**Grid Code
Modification Proposal Form**

Title of Modification Proposal: Correction of 220kV P/Q graph for remote-end Interconnector Converter Stations

MPID (EirGrid Use Only): 302

Date:	24/10/2022		
Company Name:	EirGrid		
Applicant Name:	Niamh Daly		
Email Address:	Niamh.Daly@EirGrid.com	Tel:	NA
Grid Code Version:	Version 11		
Grid Code Section(s) Impacted by Modification Proposal:	CC.7.5.10 (f)

CC.7.5.10 Interconnector Reactive Power

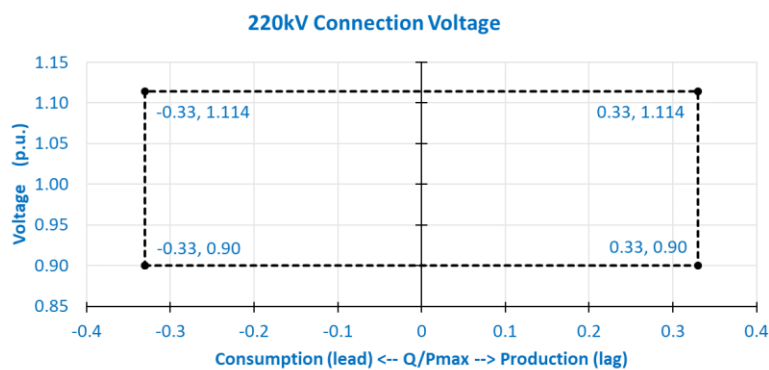
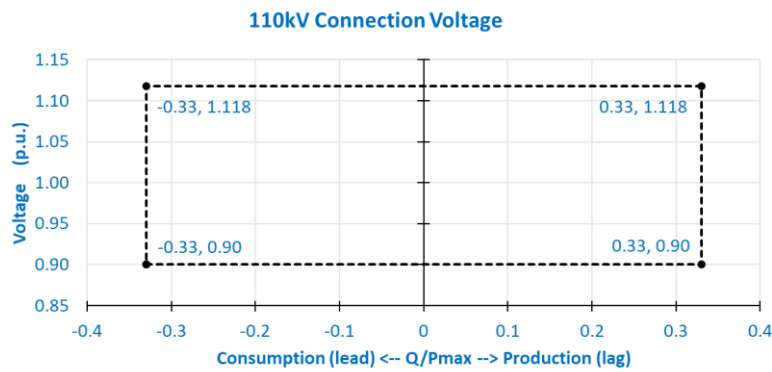
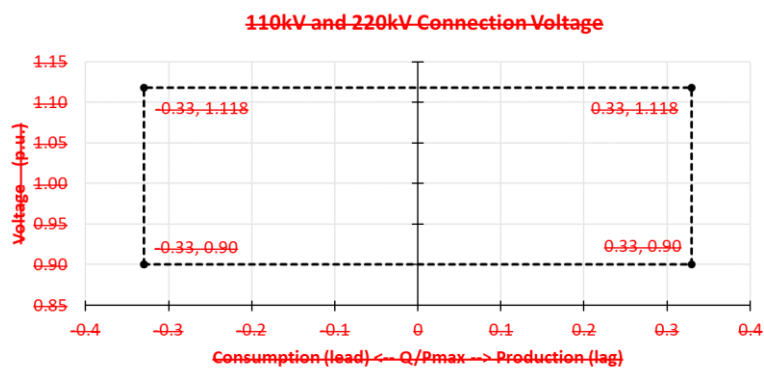
The graphs within clause CC.7.5.10(f) show a maximum voltage withstand capability of 1.118p.u. for connections at 110 kV and at 220 kV. In the case of 220 kV, this would require equipment to have the capability to continually withstand 246.4 kV. As per clause CC.8.3.2, the maximum transmission system voltages during a transmission fault for 220 kV are nominally 245 kV. This equates to an upper voltage limit of 1.114p.u. for 220 kV transmission systems.

To rectify this error in clause CC.7.5.10(f), we propose separating out the graphs for 110 kV and 220 kV, retaining the upper voltage limit for 110 kV systems of 1.118 p.u. and correcting the upper voltage limit for 220 kV systems to 1.114 p.u.

- (f) A remote end **Interconnector Converter Station** shall be capable of providing **Reactive Power** as per the following requirement at its maximum **Active Power** transmission capacity (P_{max}) at the **Connection Point**:
